OCPP 1.6 Errata sheet

2025-04

# Errata sheet: for OCPP version: 1.6 edition 2 and 1.6 FINAL.

Figure 1. Sequence Diagram: get diagnostics

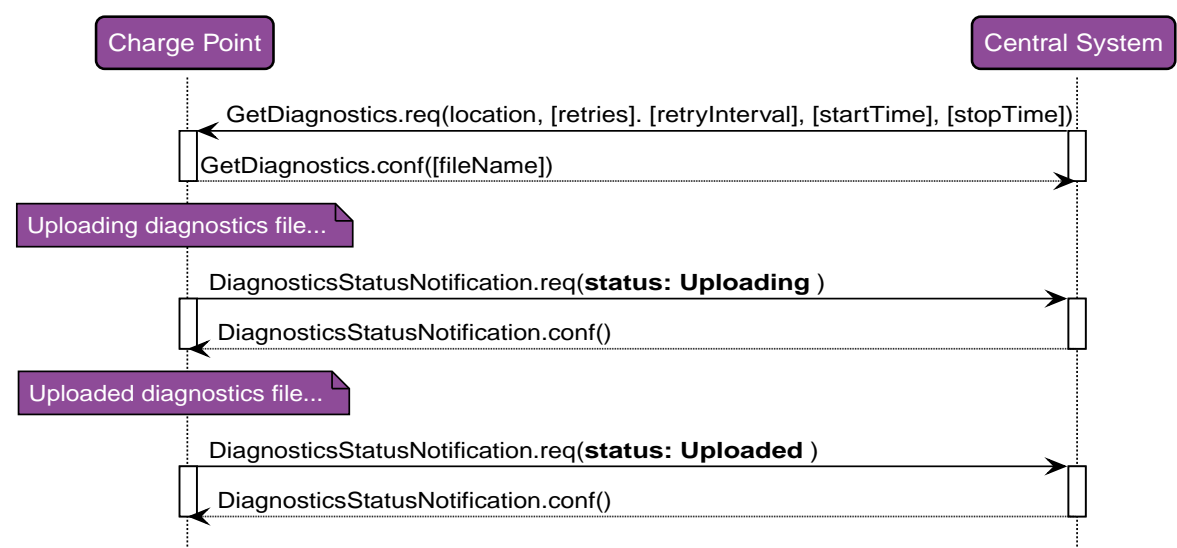
3.31. Page 51, section: 5.9: Relation between GetDiagnostics.req and DiagnosticsStatusNotification.req is missing.

There is no description about the relation between GetDiagnostics.req and DiagnosticsStatusNotification.req in the specification.

The following diagram should replace the diagram in 5.9.

Additional text	During uploading of a diagnostics file, the Charge Point MUST send DiagnosticsStatusNotification.req PDUs to keep the Central System updated with the status of the upload process.
-----------------	---

Figure 2. Sequence Diagram: firmware update

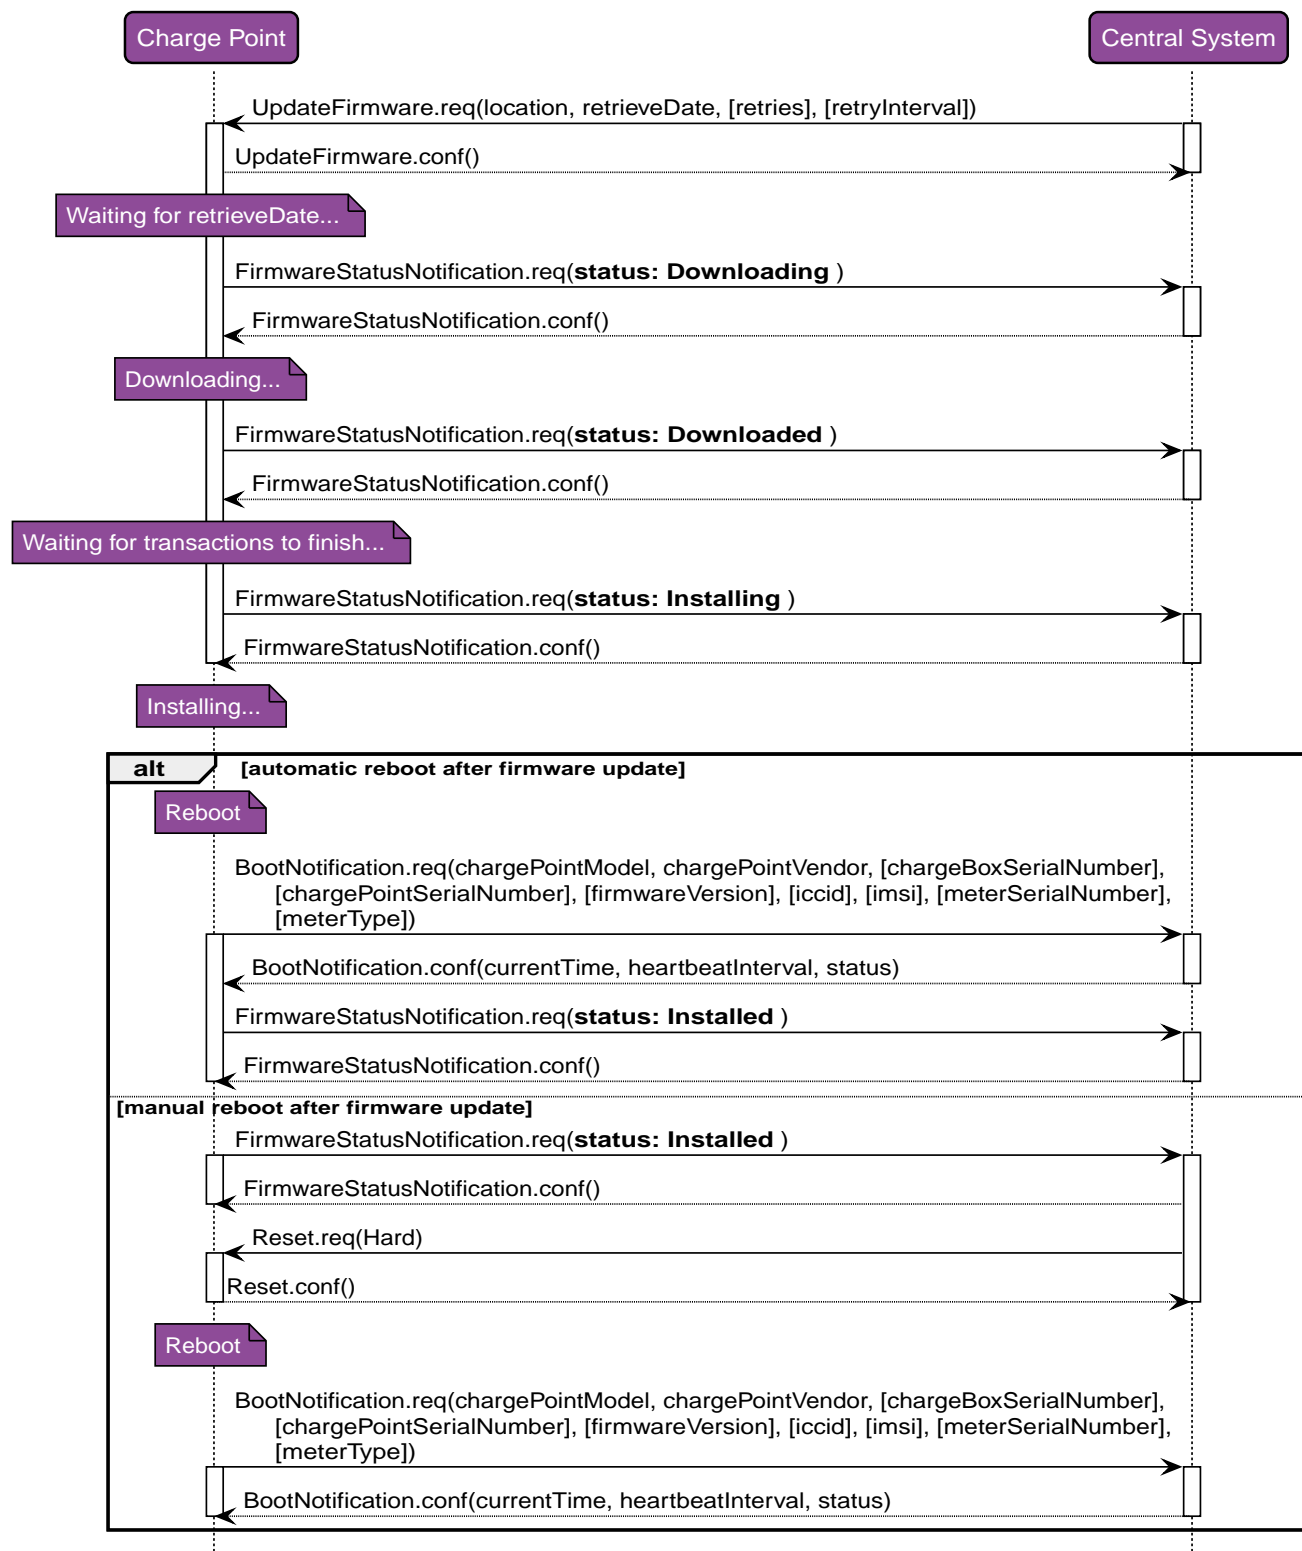
There is no description about the relation between FirmwareUpdate.req and FirmwareStatusNotification.req in the specification. In paragraph 3.3 on page 15, there is a more elaborate diagram of firmware update, including the relationship between UpdateFirmware.req and FirmwareStatusNotification.req, but that paragraph is informative.

The following diagram should replace the diagram in 5.19.

Additional text	<p>During downloading and installation of the firmware, the Charge Point MUST send FirmwareStatusNotification.req PDUs to keep the Central System updated with the status of the update process.</p> <p>The sequence diagram above is an example. It is good practice to first reboot the Charge Point to check the new firmware is booting and able to connect to the Central System, before sending the status: Installed. It is not a requirement.</p>
-----------------	---

Figure 3. Updated Sequence Diagram: Clear Charging Profile

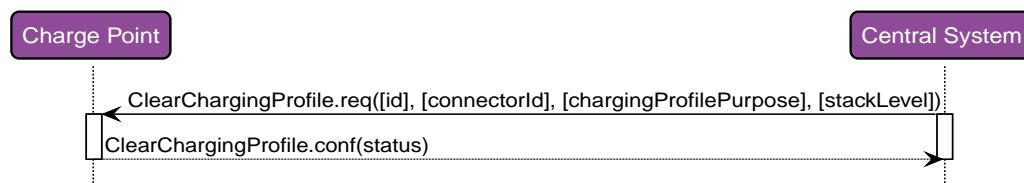
The sequence diagram on page 50 for Clear Charging Profile contains a typo. It contains the incorrect response: "ClearCache.conf" instead of "ClearChargingProfile.conf"

Update diagram for section: 5.5 on page 50:
